Tandy's Lane Adamstown

Phase 2

ARCHITECTURAL RFI PLANNING RESPONSE

AUGUST 2022

2.1 Phase 3: Future Village Centre (Indicative Only - Not Subject To This Application)

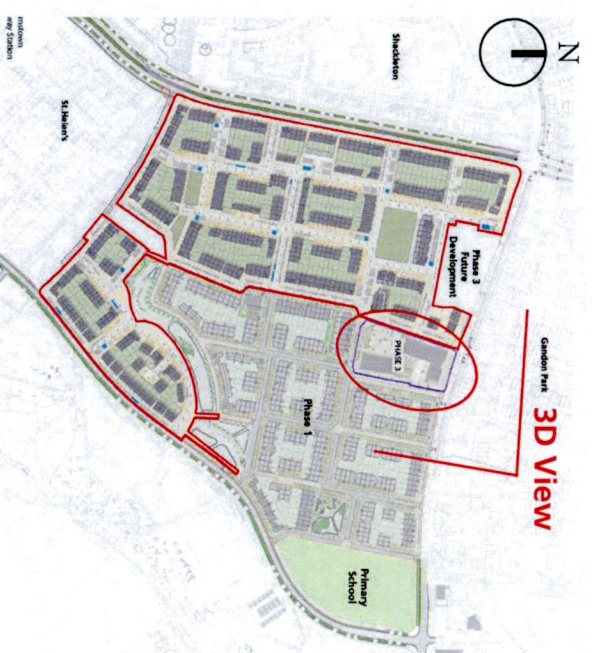
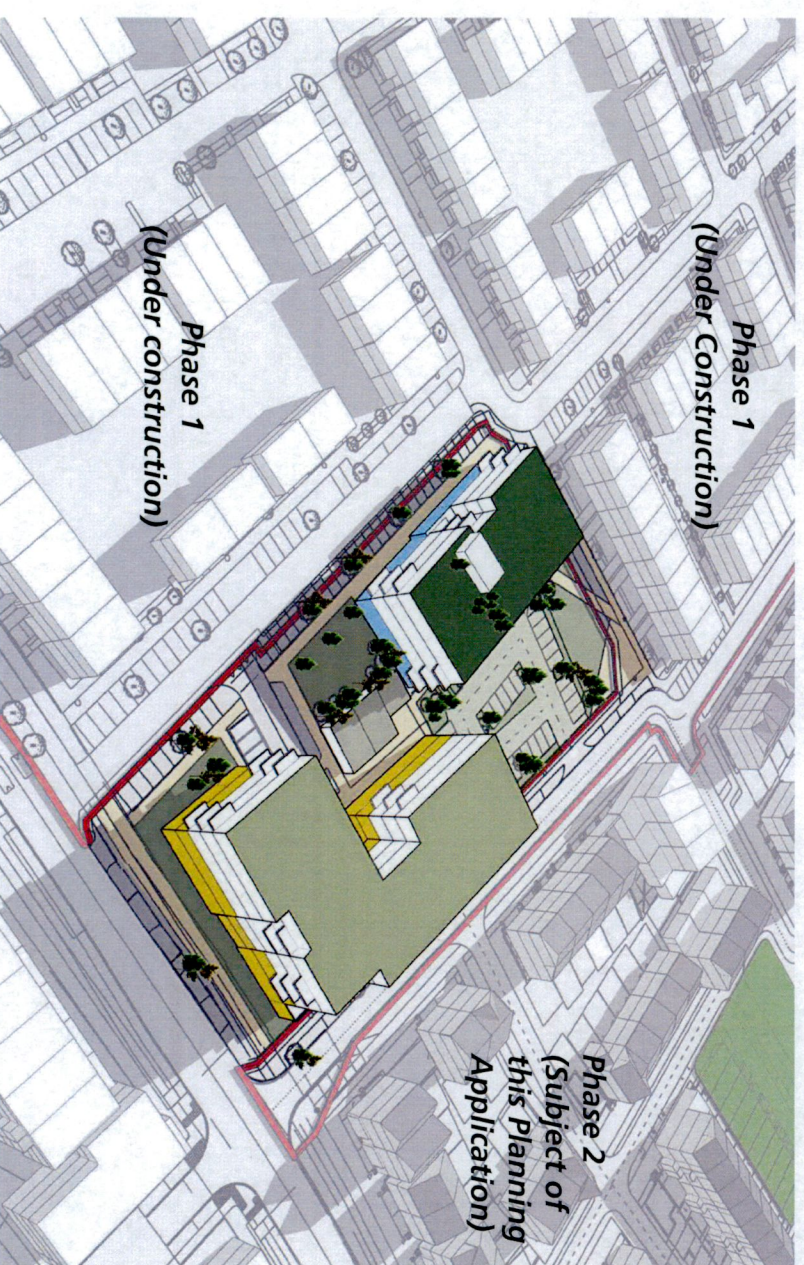
One of the key parameters for Development Area No. 6 Tandy's Lane Village is a minimum of 100 no. childcare places and 1,620sq.m retail/retail services. 1,650sq.m of non-residential floorspace has been indicated for the Local Centre in Phase 3. However, there is no indication how the 100 no. childcare places would be provided for. The applicant is requested to clarify how this would be provided for. The applicant is advised that the Planning Authority would welcome the delivery of the childcare places as part of this phase of Tandy Lane.

An indicative layout has been prepared for the Future Village Centre providing approximately 1637 m² of retail/retail services floor area with approximately 63 apartments in the upper floors. In addition to this, a creche accommodating 100 children can also be accommodated on this site.

A public plaza connecting to Phase 1 can be provided at this location and will allow for greater eastwest permeability between Phase 1, 2 and 3.

Revised Layout
(Resubmitted in response to RFI)

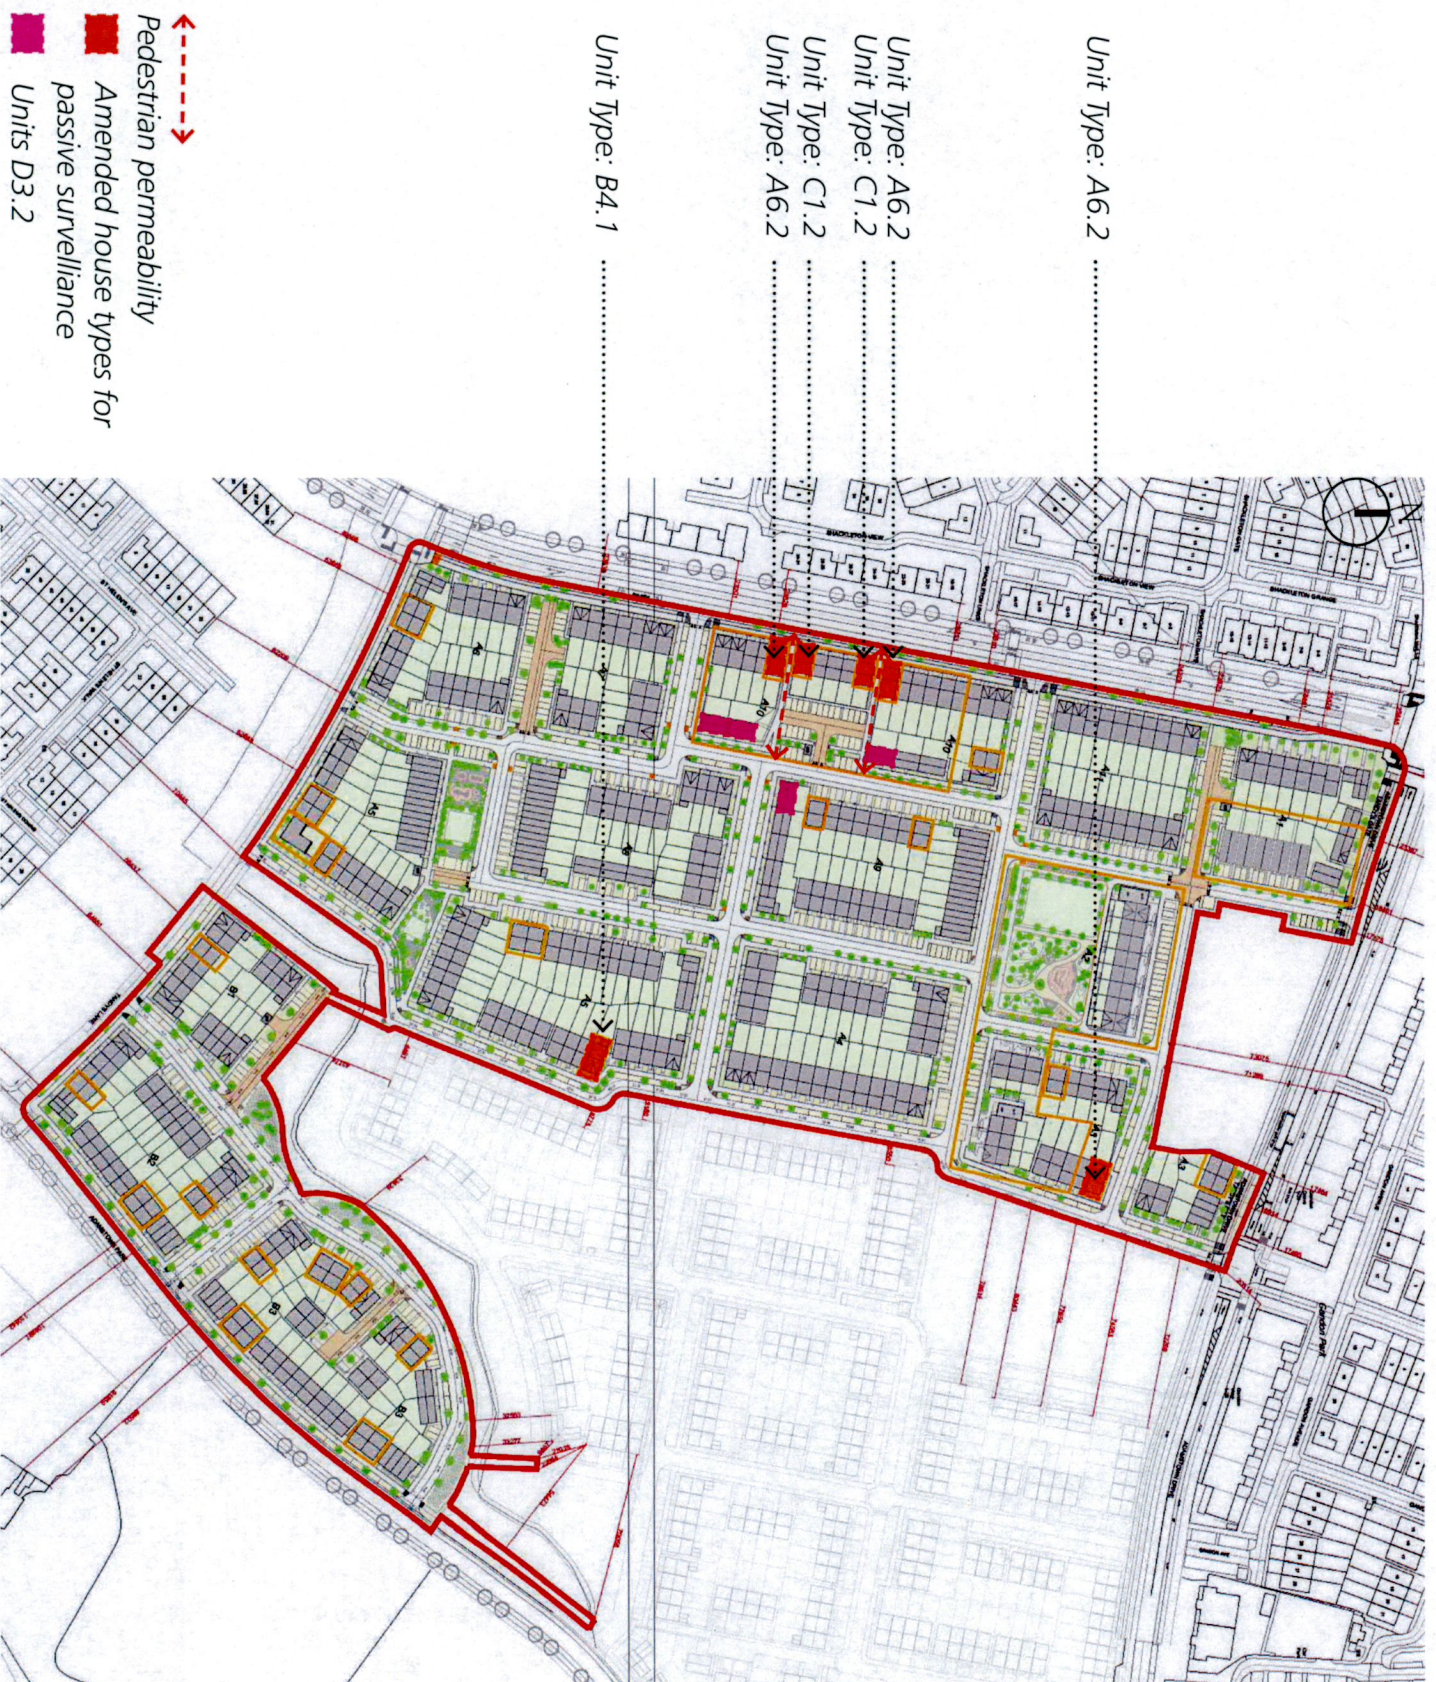
The following is requested in relation to the layout and design of the proposed development:

3 (B) Passive surveillance

(b) It is not considered that sufficient passive surveillance of public footpaths where they run between the sides of houses is provided for. Further windows to habitable rooms on the side elevations (including at ground floor) of these house types should be provided.

The units highlighted in orange on the adjacent plan have been revised to provide additional and/or larger windows to habitable rooms to improve passive surveillance over adjacent pedestrian routes. A privacy strip is still provided between the houses and the public footpaths.

A new A6 house type variant, A6.2, is provided with additional and larger windows overlooking the adjacent footpaths to increase the level of passive surveillance in the locations shown.

A new C1 house type variant, C1.2, is proposed to better address the corner and public footpaths, as shown on the plan, with habitable rooms fronting onto the footpaths providing windows that overlook the public areas.

In addition, an existing front-entry unit B6 at the east of the site has been replaced by a side-entry unit B4.1, which improves the passive surveillance over the adjacent public road and footpaths in this location.

Existing house type D3.2 (4no. highlighted in pink) has a minor amendment to provide additional brick on the gable elevation to address the adjacent public footpaths and roads.

3.5 3 (B) Passive Surveillance - Unit Types

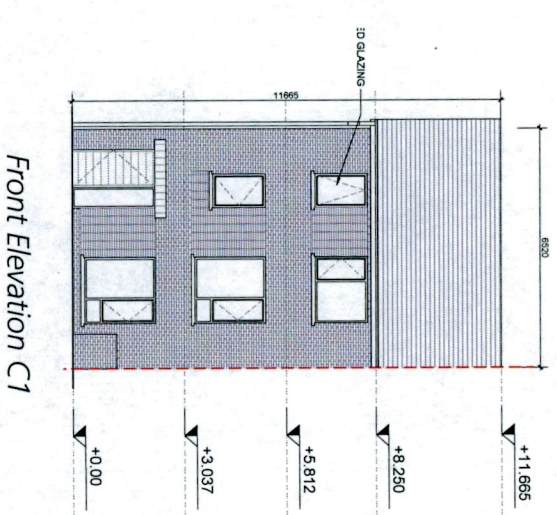
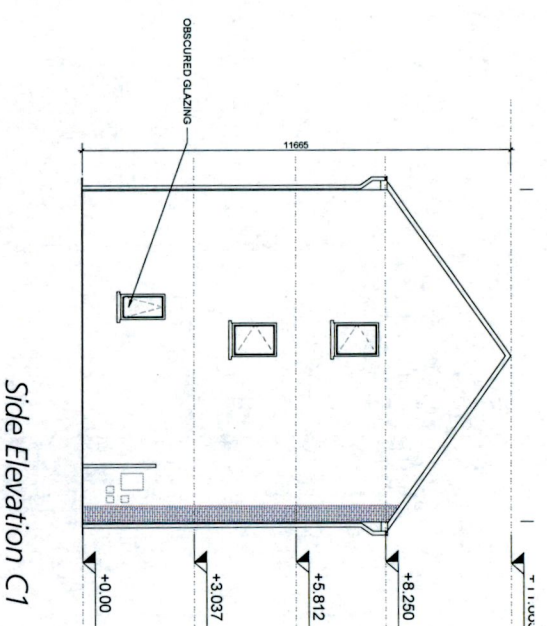
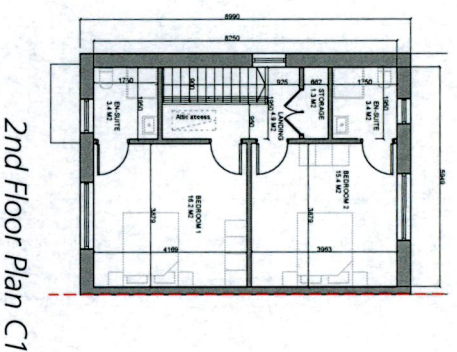
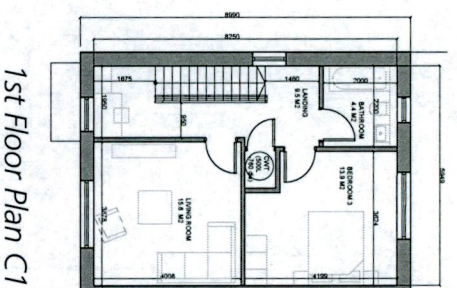
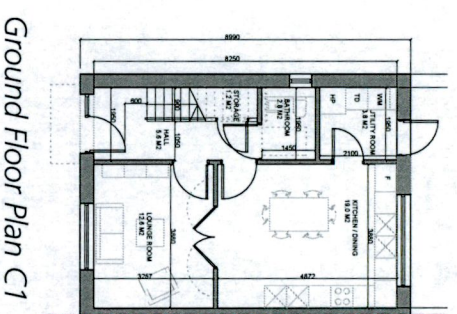
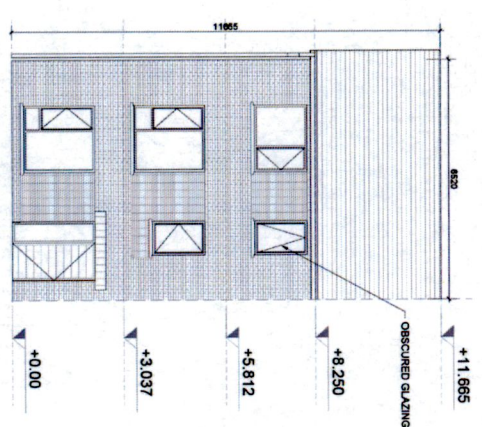
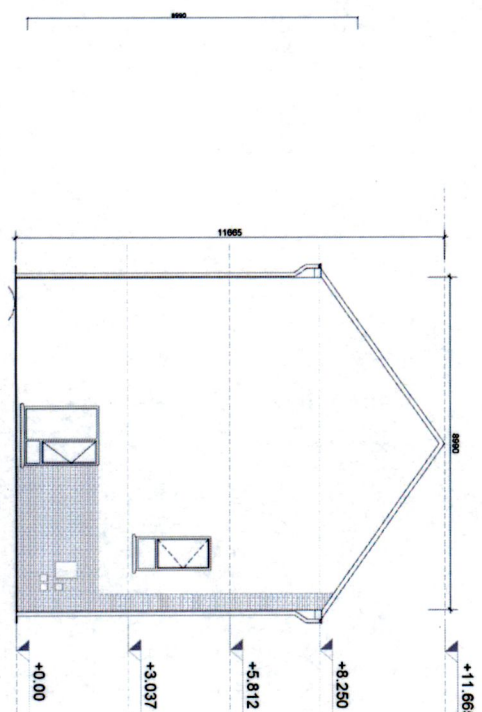
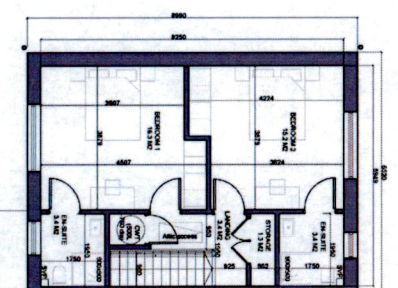
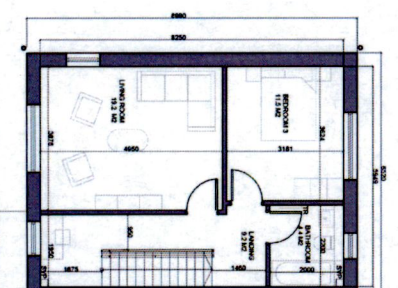
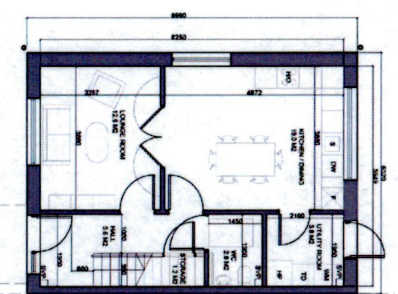
Amendment:
New units added to the site plan: C1.2

(Larger windows from habitable rooms provided overlooking footpath)

3.6 3 (C) Landmark Building - Approach

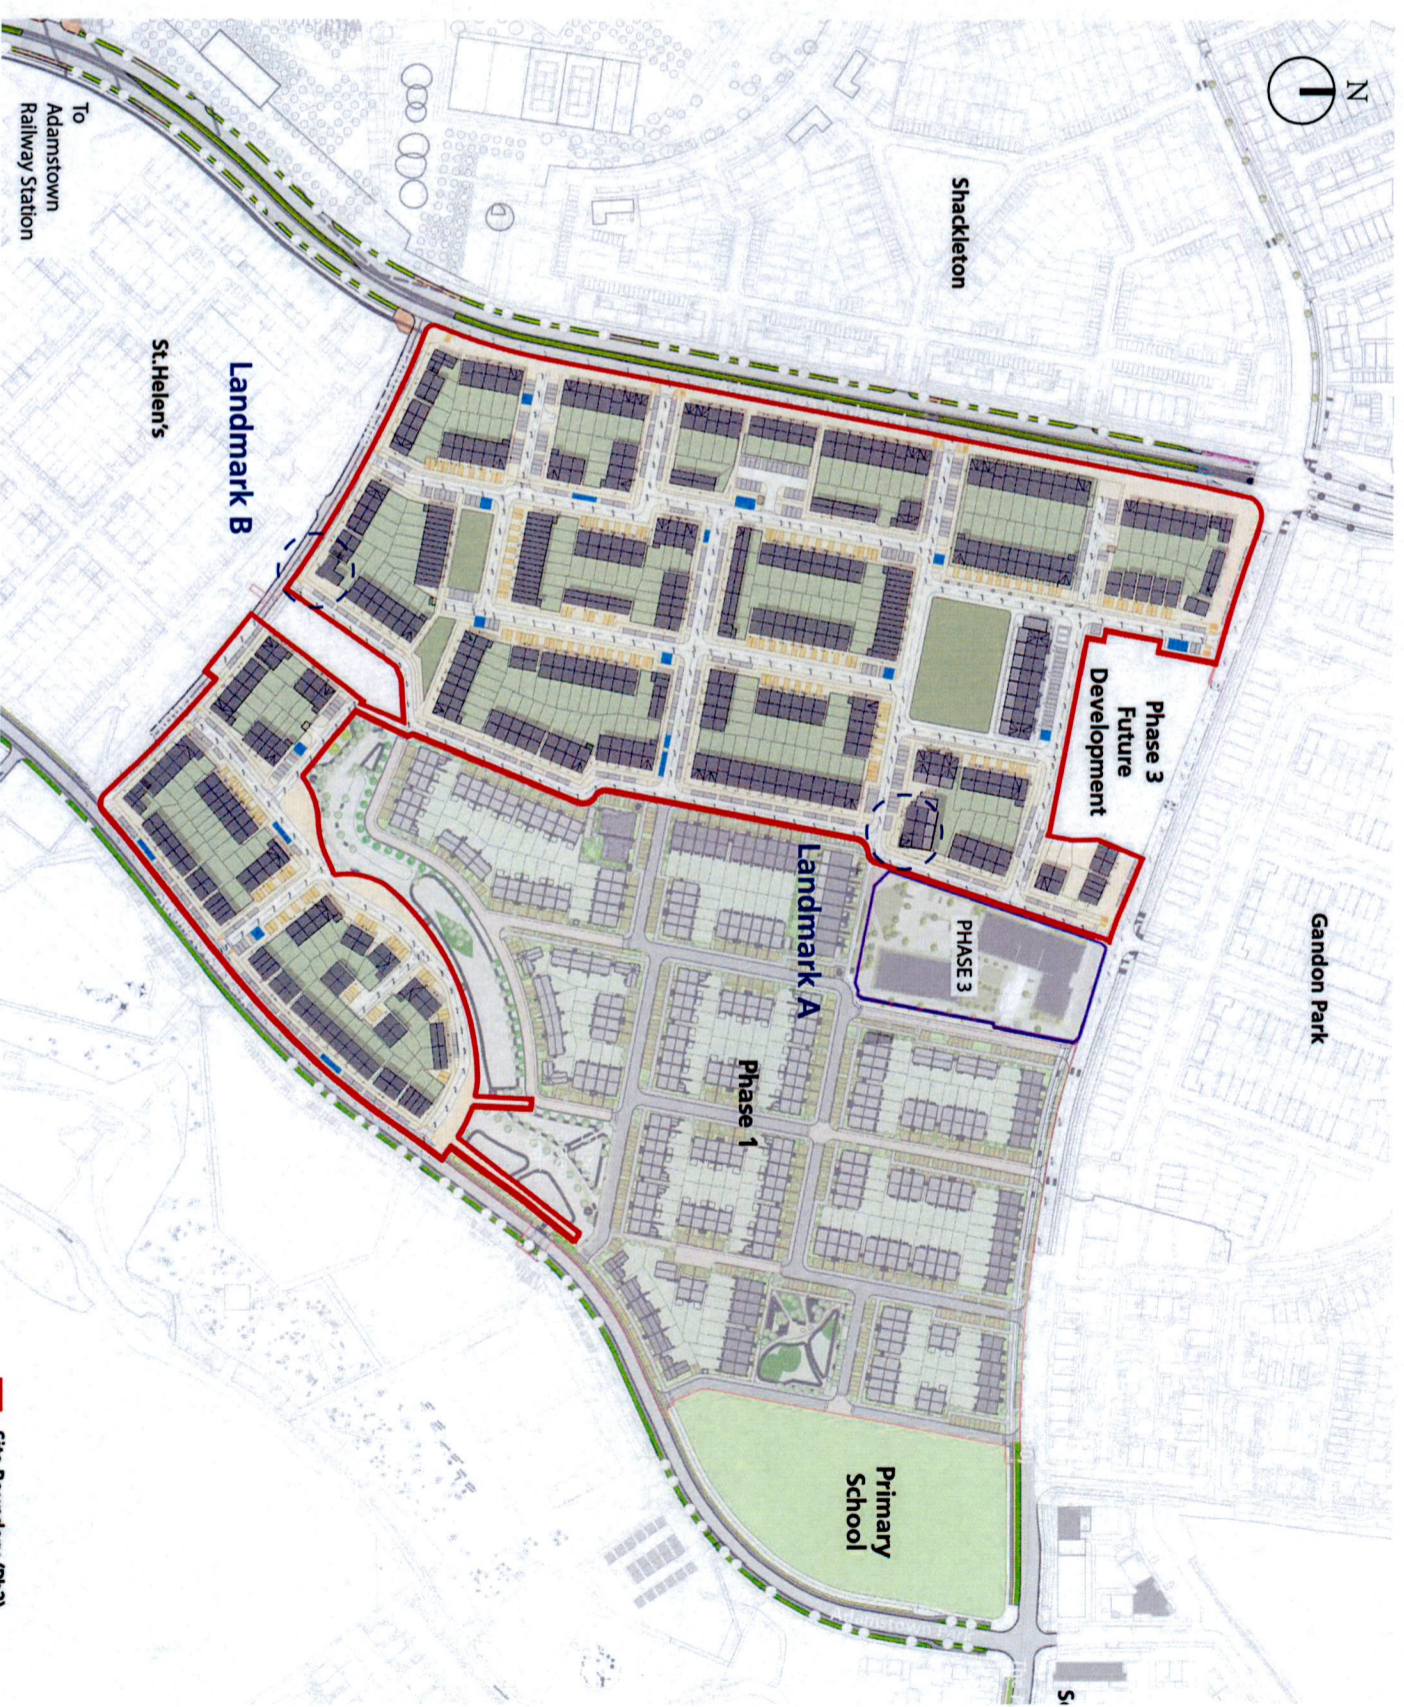
(c) The Planning Authority does not consider the proposed landmark buildings to be discernible enough for wayfinding. The height and form of the buildings would not be so different to adjacent houses. Further consideration needs to be given to revising these buildings to act as landmarks. The height does not necessarily need to be increased. However, the design quality of the buildings does need to be significantly enhanced so that they are clearly discernible from adjacent buildings. The applicant is therefore requested to submit a revised proposal for the landmark buildings. Revised drawings and other relevant documentation should be submitted.

The design of the 2no. landmark buildings on the subject site, has been reconsidered to enhance the design quality and material palette, in order to provide clearly discernible buildings. They define key corners with sharp lines and height at their key nodal points and create a desire line to the future Village Centre.

Discernible features are as follows:

- 3 storeys in height
- Changes in pitch to identify significant corner
- Variation in roof profiles to break the parapet line.
- Free-standing/detached
- Full brick facades to street elevation is proposed with contrast to the half render / half brick to neighbouring buildings
- Brick wraps around all street facades, creating a monumental expression
- Additional detail to window reveals and vertical grouping emphasising verticality
